James Taylor Construction

3654-PL-615
SECTION A-A - AS PROPOSED

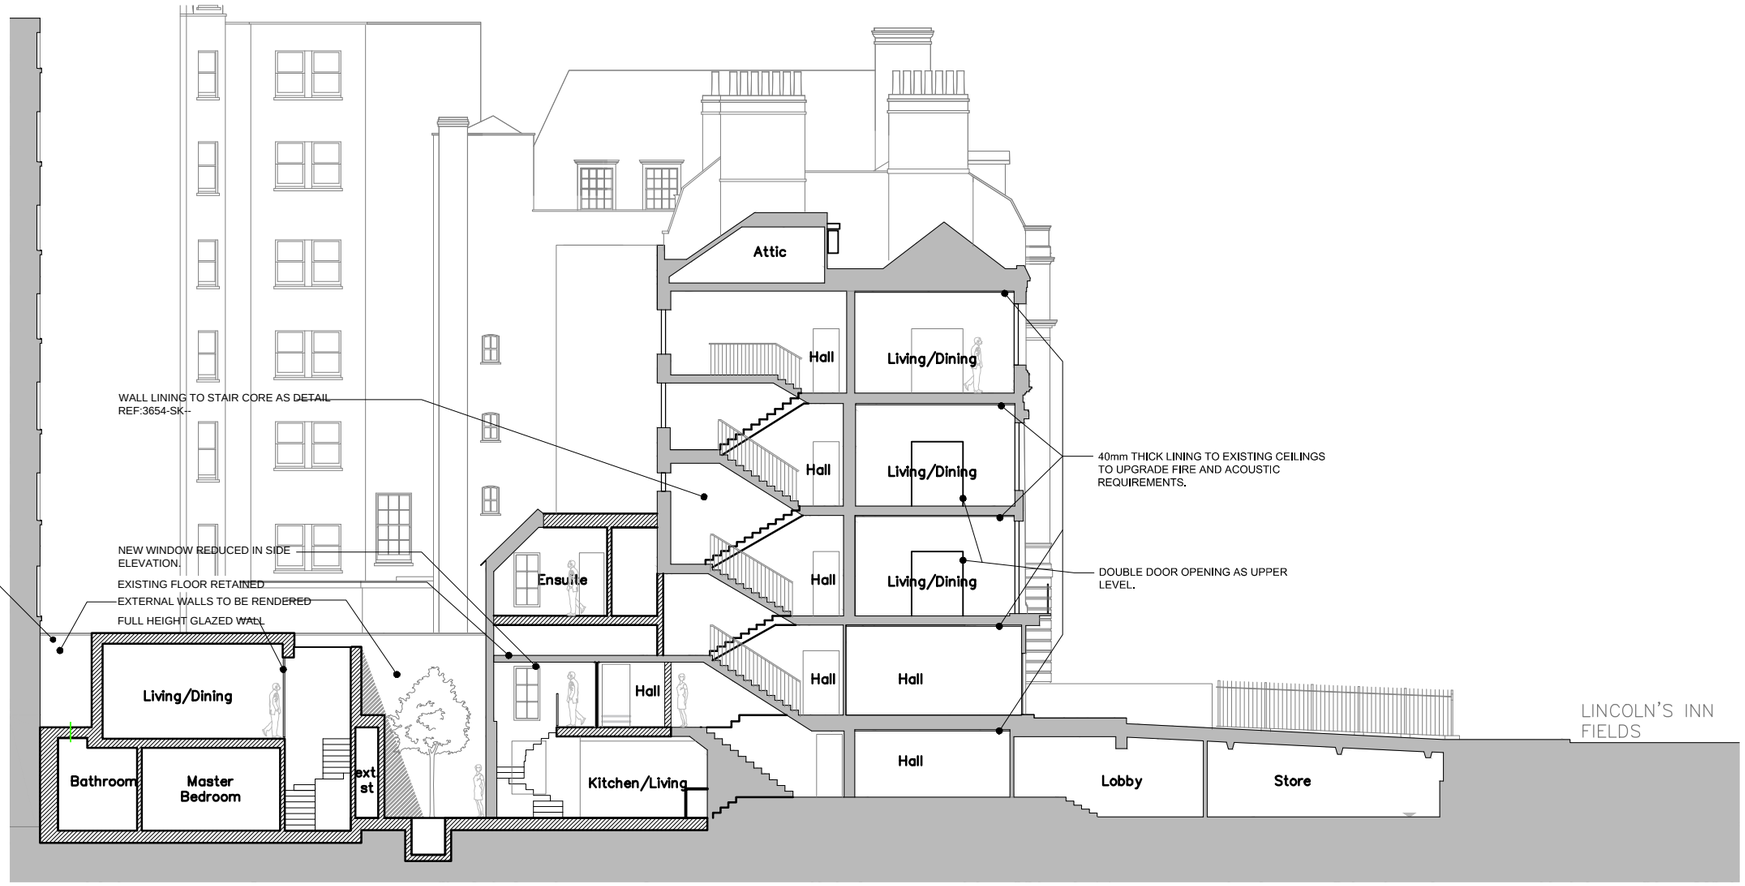
REASONING TO CHANGES OF FINISHES TO PARTY WALLS.
APPROVED GLAZED BRICKS TO BE REPLACED WITH RENDERED WHITE WALLS DUE TO THE IMPLICATIONS STRUCTURALLY TO THE EXISTING PARTY WALLS. THE EXCAVATIONS HAVE REQUIRED STRUCTURAL IMPLICATION SO THAT THE RENDERED FINISH TO THE EXISTING AREAS IS THE MOST REASONABLE SOLUTION. THIS WILL PROVIDE A CONTEMPORARY CLEAN APPEARANCE AND BE IN KEEPING WITH THE WHITE RENDERED EXTENSION WALLS.
